## North Coast Regional Water Quality Control Board

Subject: Notice of Violation, Transmittal of Inspection Report for September 7,

2023, Inspection of Humboldt County Assessor's Parcel Number 107-

File: Cannabis Program Inspections, Humboldt County, September 7, 2023,

P8

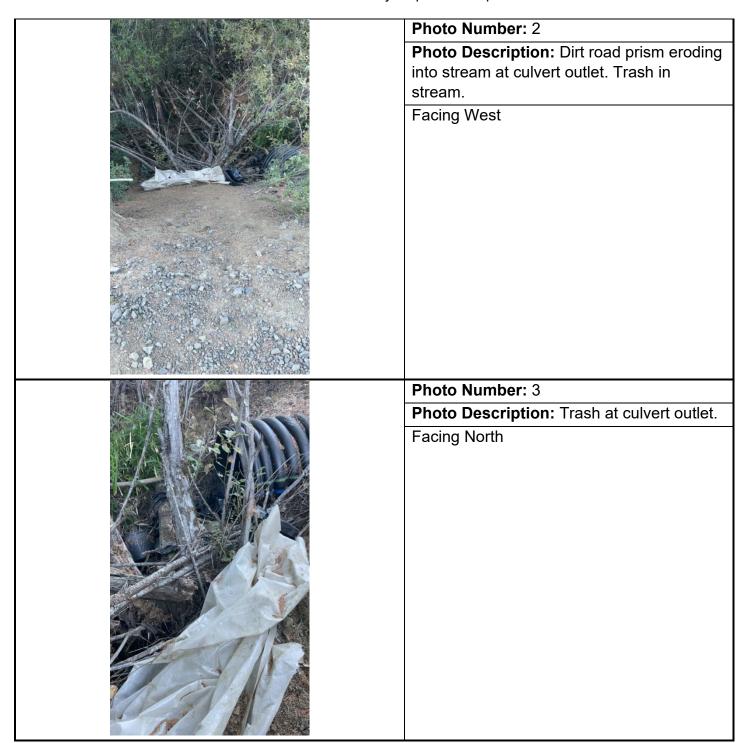
P8: I observed a plastic culvert stream crossing with ponding at its inlet. I observed a disconnected submersible pump in the ponded area. I observed a road ditch discharging to the stream at the culvert inlet. I observed trash at the culvert outlet, and the road prism eroding into the stream.

**Photo Description:** Culvert inlet with ponding, and submersible pump.

- 4. Retain a qualified professional to assess the culvert stream crossings for capacity to convey a 100-year flow event and associated debris, disconnect road ditches from watercourses, and recontour roads to prevent discharge to receiving waters.
- 5. Apply for a 401 water quality certification prior to work instream to replace culverts.
- 6. Work with the State Water Board Division of Water Rights and the California Department of Fish and Wildlife to obtain necessary permits to divert and store water.
- 7. Do not use water storage bladders unless the bladder is safely contained within a secondary containment system with sufficient capacity to capture 110 percent of a bladder's maximum possible contents in the event of bladder failure.

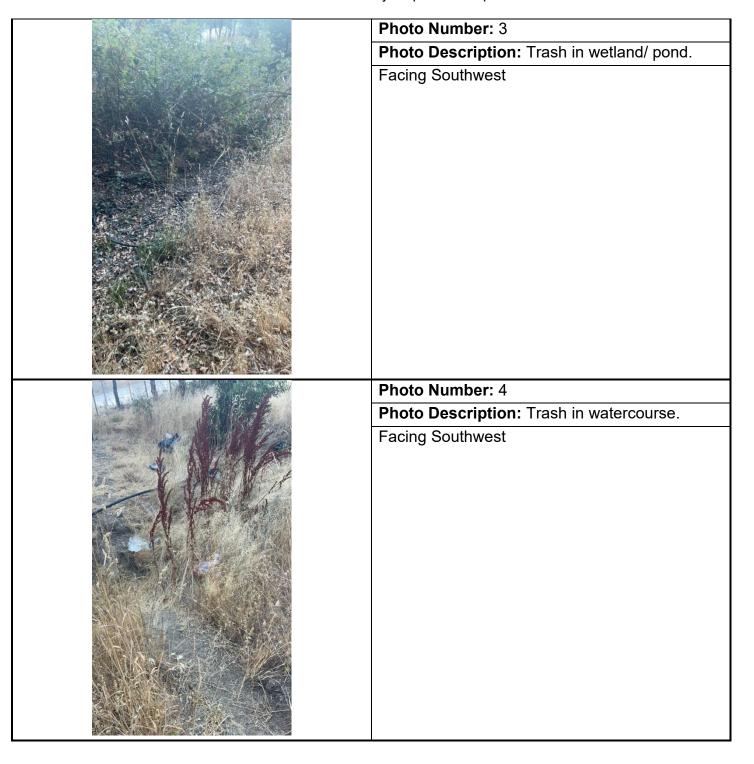
L1: I observed a watercourse channel with portions of cobble substrate, and dirt substrate. I observed cultivation related waste in the stream. I observed the stream discharges to a pond/wetland feature.

L1				
Category: Riparian Areas (RA)				
<b>Description:</b> Watercourse discharging into wetland/ pond feature.				
	Photo Number: 1			
<b>《四周》</b> 《四周》	Photo Description: View of watercourse			
	channel with cobble.			
	Facing East			
Section 1				
	Photo Number: 2			
	Photo Description: View of watercourse			
	channel with reduced slope approaching			
	wetland/ pond area. Facing West			
	r acing west

- 1. If you and/or your tenant(s) plan to continue commercial cannabis cultivation, enroll for coverage under the State Water Board's Order WQ 2019-0023-DWQ, General Waste Discharge Requirements and Waiver of Waste Discharge Requirements for Discharges of Waste Associated with Cannabis Cultivation Activities.
- 2. Relocate all cannabis cultivation activities, supplies, and trash outside of the riparian setbacks (50 feet from Class III, 100 feet from Class II, 150 feet from Class I).
- 3. Regularly contain and dispose of all waste/ trash, including used motor oil, at a licensed transfer site. Remove cultivation related waste from surface waters.
